Bugs in the BOSS GS-10

9 August 2005
Mark van den Berg

The BOSS GS-10 Guitar Effects System is a great device. However, the GS-10 does seem to contain several bugs, which may have to be fixed by means of a firmware upgrade. This document describes these problems.

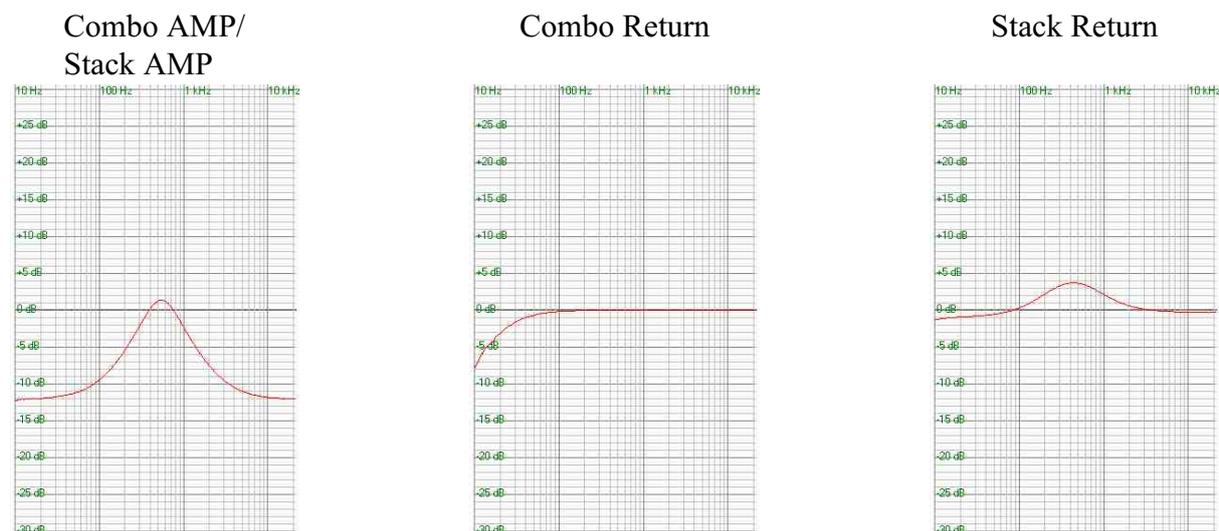
However, there is an inconsistency in the relationship between Patch Level and the USB tap:

However, it turns out that this order does *not* occur. Instead, Patch Level now *does* affect the signal sent from the GS-10 to the USB connection. In other words, it's as if Patch Level and the USB tap are *reversed* here:

I don't know whether this contrasting behavior is intended or not. However, it is definitely very confusing when one is playing around with the USB tap's position in the chain.

Obviously there are two ways this behavior could be made consistent: to have Patch Level *never* affect the USB tap, or to have Patch Level *always* affect the USB tap. (The latter would of course require the application of a 'copy' of Patch Level within the USB tap itself – i.e. after the split-off point from the rest of the chain.) Which of these two solutions is preferable is open to debate; personally I would probably like Patch Level to *always* affect the USB tap.
